COUNCIL ASSESSMENT REPORT

Panel Reference	2018SNH039
DA Number	DA-2018/158
LGA	Willoughby City Council
Proposed Development	Demolition of existing two (2) storey commercial building and erection of a new four (4) storey commercial building comprising of office space and trafficable roof top at Victoria Avenue frontage and demolition of existing retail tenancy and erection of fifteen (15) storey hotel at Brown Street frontage
Street Address	475-501 Victoria Avenue, Chatswood
Applicant/Owner	Cromwell Diversified Property Trust/ Cromwell BT Pty Ltd
Date of DA lodgement	25 May 2018
Number of Submissions	11 submissions
Recommendation	Deferred Commencement
Regional Development Criteria (Schedule 7 of the SEPP (State and Regional Development) 2011	Capital investment value (CIV) over \$30 million
List of all relevant s4.15(1)(a) matters	<ul style="list-style-type: none"> • <i>SEPP (Infrastructure) 2007 - Schedule 3 – Traffic Generating Development</i> • <i>SEPP 55 – Remediation of Land</i> • <i>SEPP (Vegetation in Non-Rural Areas) 2017</i> • <i>SEPP 64 – Advertising and Signage</i> • <i>SEPP 65 Design Quality of Residential Apartment Development (SEPP 65) and NSW Apartment Design Guide (A

Figure 4: On-street pick-up and drop-off bays (Source: Traffic and Transport Assessment by Arup)

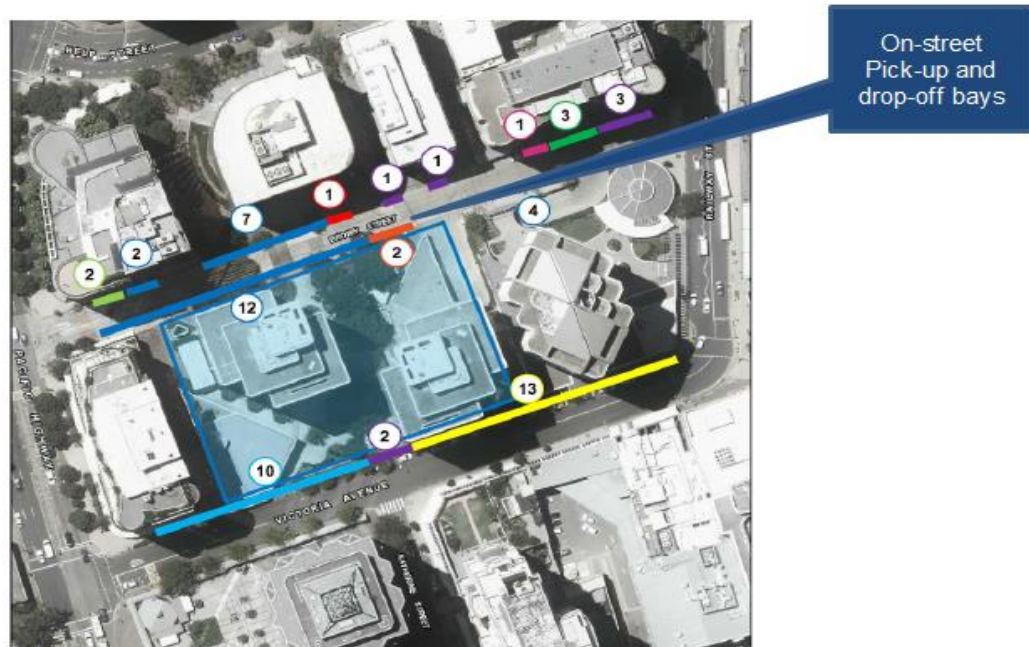
The applicant was advised to provide an off-street Porte Cochere, given the site's location and impact on the existing vehicular and pedestrian traffic. A Porte Cochere within the site would require removal of three (3) on-street parking currently provided along Brown Street.

Council's Traffic Section has assessed the revised proposal to be acceptable as there is no reliance on the existing on-street parking on Brown Street for the purpose of hotel pick-up or drop off bays. Furthermore, it is considered that there will be a minimal impact on the pedestrian movement along Brown Street as provision of a porte-cochere at ground level would create a conflict between the vehicles and pedestrian traffic flow.

Figure 6: Existing and Proposed Ground Plane Study (Source: Nettleton Tribe)

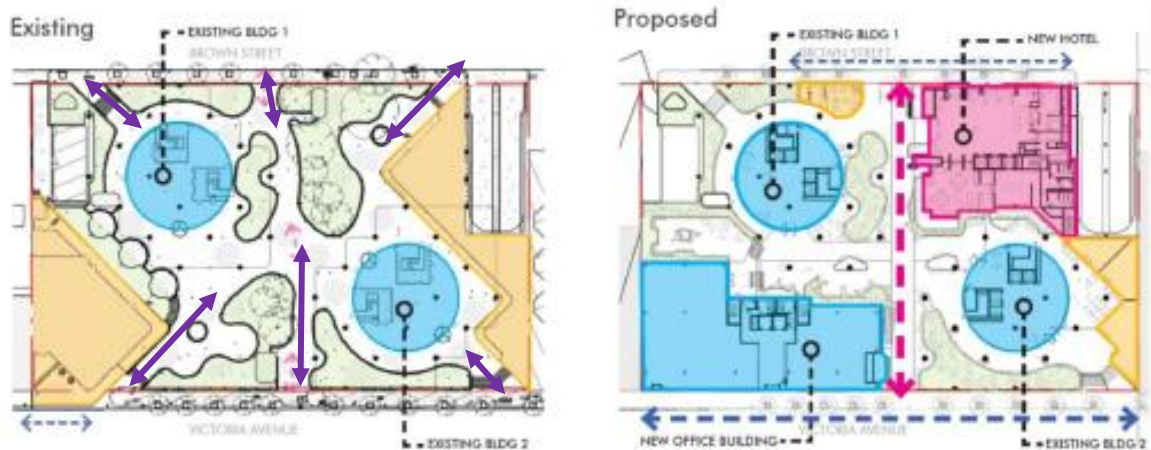
The proposal retains the north-south and northwest-southeast links however the southwest-northeast is lost to accommodate the proposed office and hotel buildings. In this regard, the current proposal includes upgrade of the existing north-south link that runs through the centre of the site by providing seating areas and vertical landscape areas as demonstrated in the perspectives below:

The *Chatswood CBD Planning and Urban Design Strategy* envision one 'through-building' link for the subject site. The proposal is therefore considered to be acceptable.

Figure 1 – Proposed Site Coverage

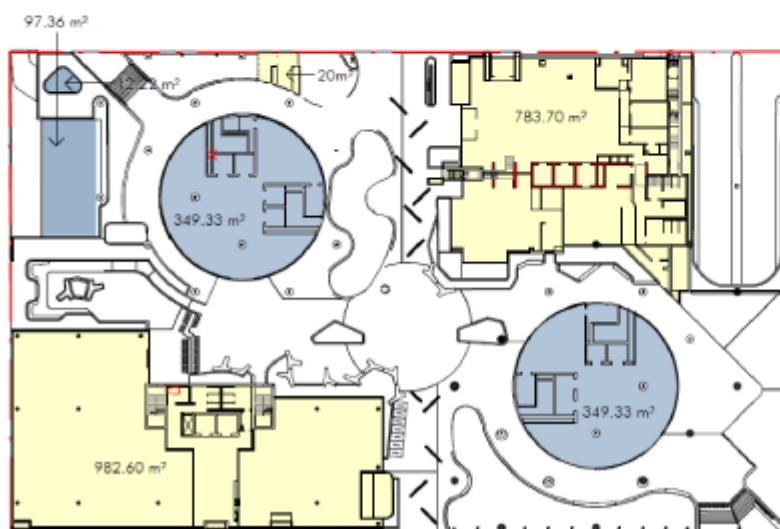
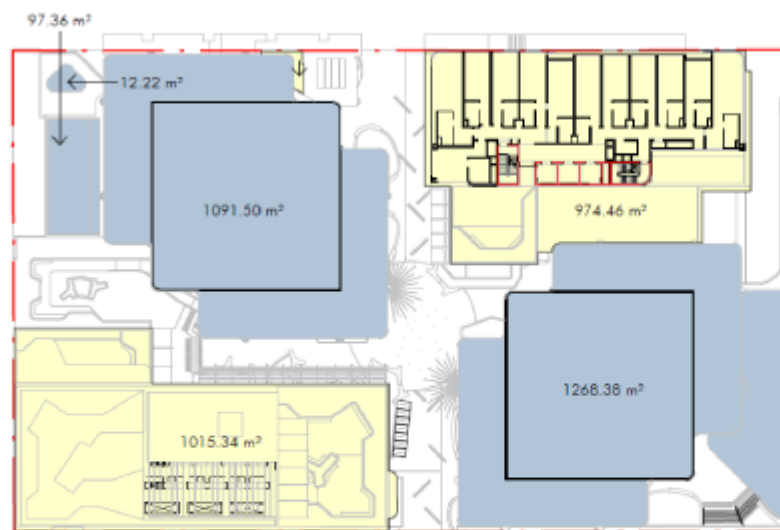
Notwithstanding, exclusion of building overhang for the purpose of calculating site coverage is not made explicit by the standard definition. For this reason, a strict interpretation of 'site coverage' that includes building overhang would arrive at a calculation of 74% rather than 43% for the subject site.

For abundant caution and to assist Council in its assessment of the proposal, it has been assumed for the purposes of this Clause 4.6 application that the proposal cannot rely on the FSR exception available under Clause 4.4A and an application for a Clause 4.6 variation is required.
